**WOOD CREEK
SUBDIVISION**

BETHLEHEM,
CONNECTICUT

Environmental Review Team Report

Bethlehem Inland Wetlands Commission

Revised Open Space

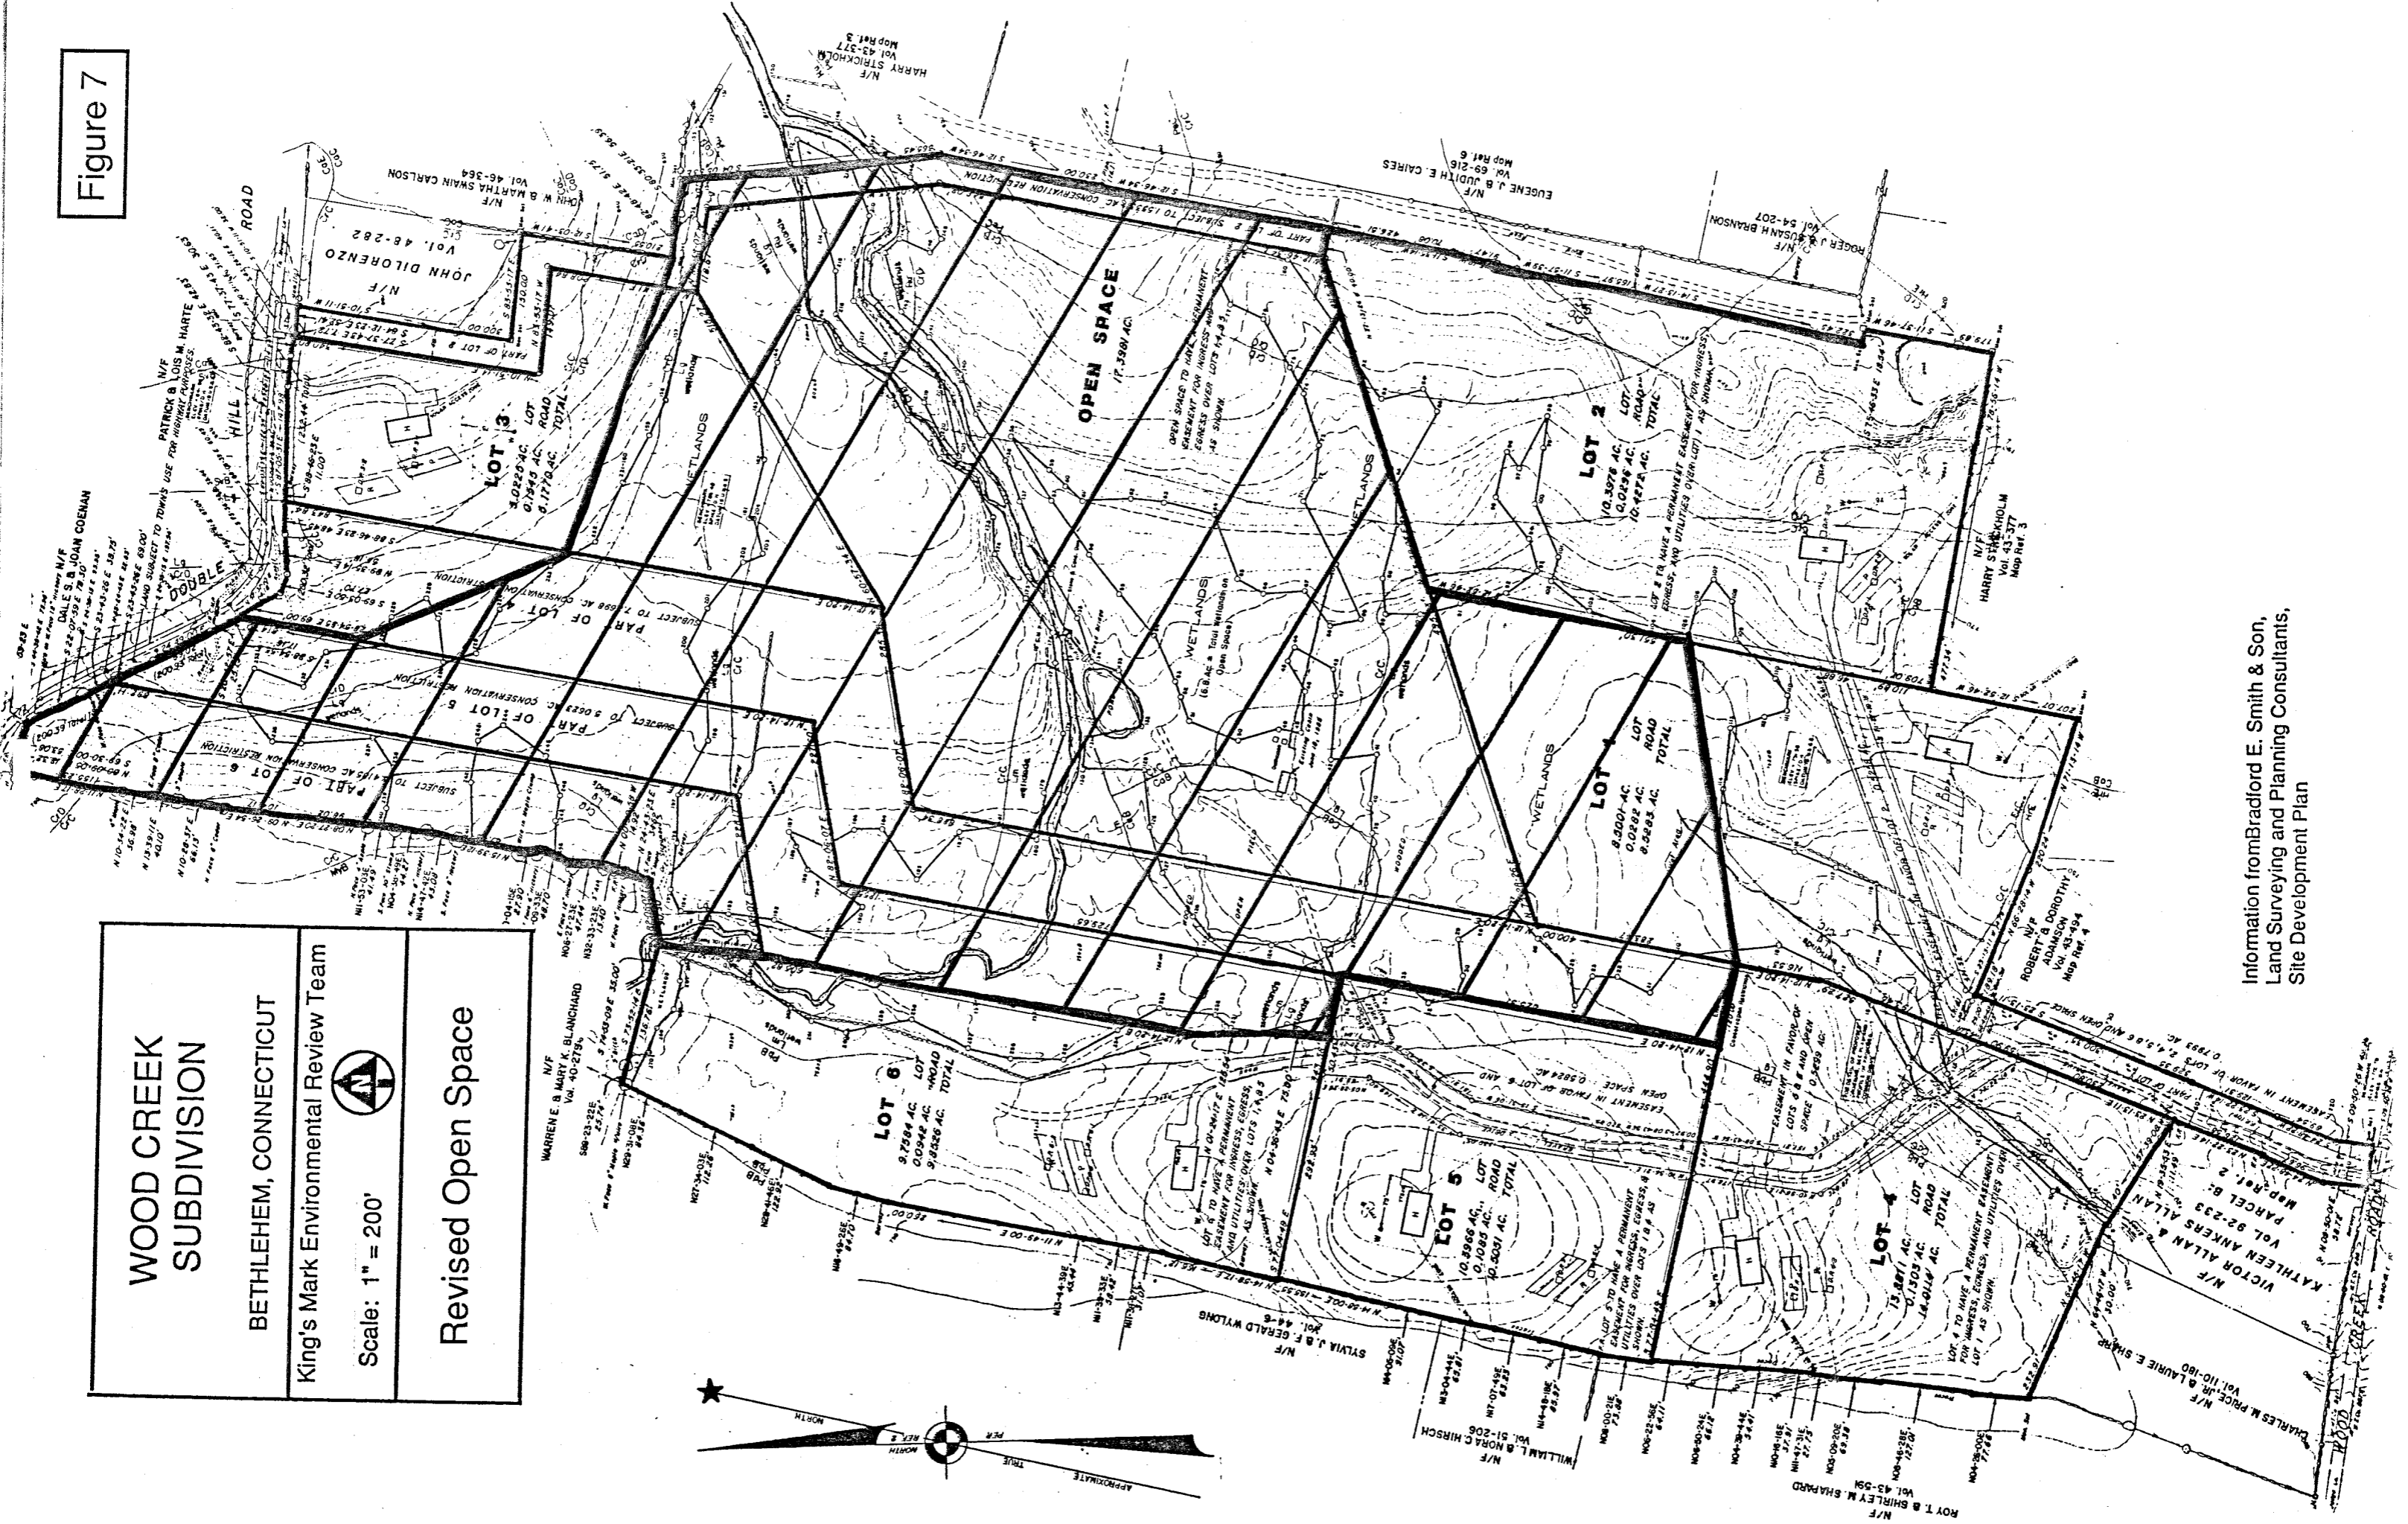
The area proposed to be left as open space does contain a variety of habitats, which is desirable for providing habitat diversity. The main brook and its branch, the pond, wetlands and some upland area are included in the 17 acres of open space. Ideally, a corridor of land (100 feet on either side) along the entire brook (the area of the 2300 foot easements of Lots 4, 5 and 6) should be included in the open space area. In addition to being an important habitat type, brooks can often function as travel corridors for many species of wildlife. This brook serves as a connection to Weekepeemee River for species using these brooks and the habitat they provide as travel corridors. If this section of brook were included as open space it would assure that the brook would not have roads built over it (to allow access from Double Hill Road) and the vegetation would not be disturbed. Insuring that there would be no habitat disturbance to the brook system would help lessen the impact of the development.

Trespass rights to open space areas could be developed for the parcels not abutting the open space. The conservation easements for Lots 4, 5 and 6 could be eliminated and become additions to the main open space area. Elimination of these easements would still leave these 3 lots with land area exceeding the subdivision requirements. As noted, the 40 foot conservation easement strip on Lot 2 effectively eliminates any public access to the stream or open space area. The municipal opportunity to effectively link permanent stream belts or open space to the east would be lost. The Commission should encourage provision for this eastward access minimally 100 feet each side of the existing stream from Long Meadow Pond.
